Technical Bulletin

No: TB069

Description: Torque Bushing Clevis Weld Interference (ECN-168-0006)

Figure 1

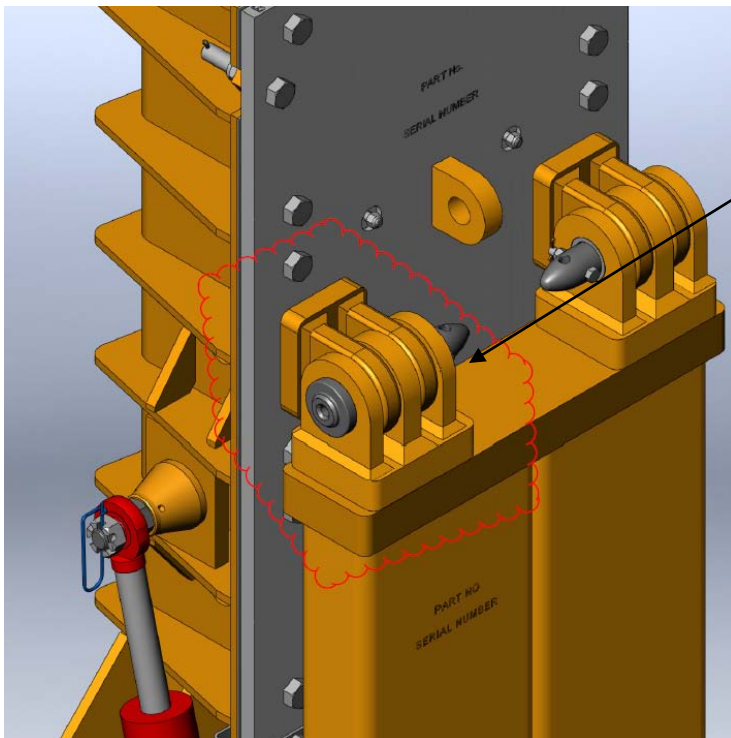
An interference problem has been identified during the manufacturing of Top Drive Torque Bushings. Weld interference is being caused due to the manufacturing tolerances of the following mating parts (See figs 1 & 2):

1. P/N 7750 – 'Clevis, Upper, Torque, Bush, HCI' – Dwg # 40000121
2. P/N 3941 - 'Clevis, Lower, Extend Frame – Dwg # 43030314
